LAND USE APPLICATION SUMMARY

Property Location: 3750 West Lake Calhoun Parkway
Project Name: New single-family home
Prepared By: Joseph R. Giant, City Planner, (612) 673-3489
Applicant: Ippocratis & Ashii Vrohidis
Project Contact: Charlie Simmons
Request: To construct a single-family home with attached garage.
Required Applications:

BZZ-7267

1 Site Plan
 SCALE: 1/8" = 1'-0"

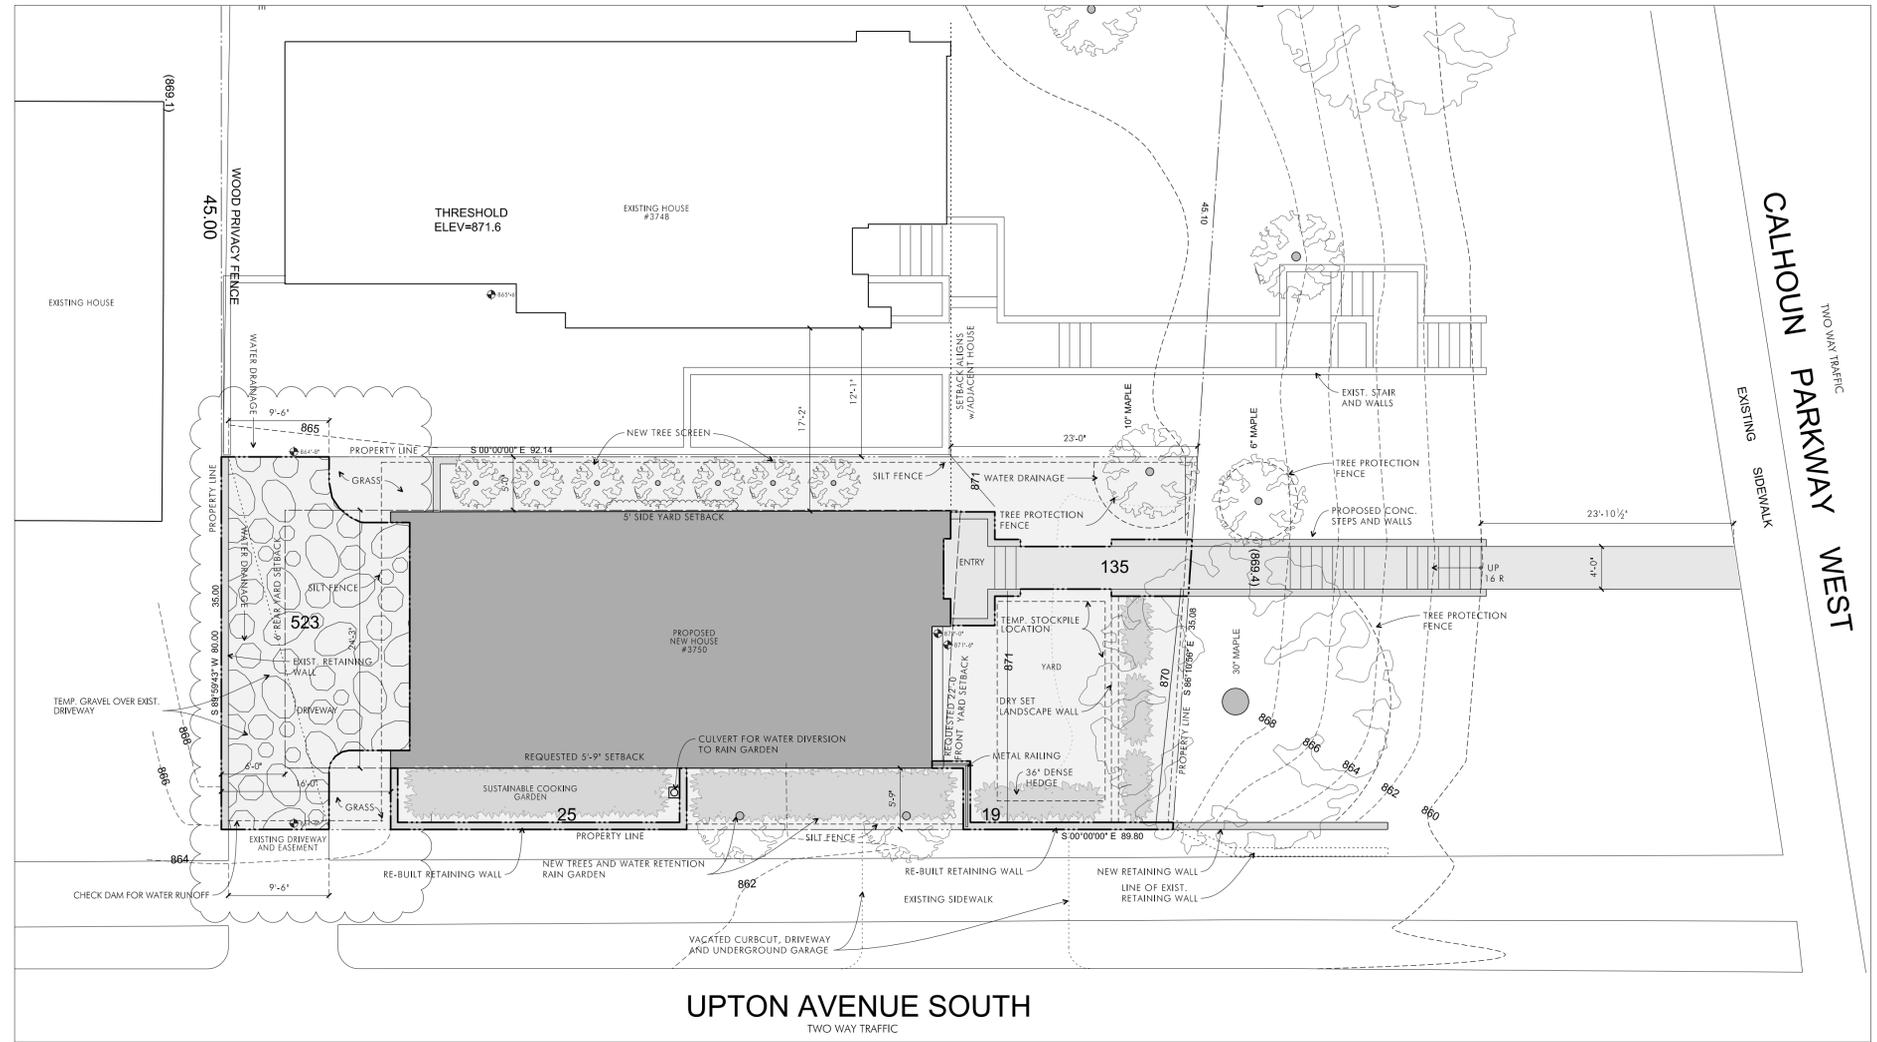
An erosion control plan, which can be found in the Additional Materials, details the preventative steps that will be undertaken to protect the hillside both during and after construction. In addition to best practices regarding soil stabilization, the plan contains other site management and maintenance components that will be implemented to ensure that the development presents no danger of falling rock, mud, uprooted trees or other materials (551.470[3]). Examples include the utilization of fiber rolls placed across the construction entrance and decomposable filter rolls around the house that will be used until the final landscaping has been established.

Trees and existing landscaping are usually regarded as the best form of erosion control. The site plan and erosion control plan indicate that no mature trees will be removed during development. A stand of vegetation, including a maple with a trunk diameter of 30", exists just past the northeast corner of the property. These are located on park property and must be preserved.
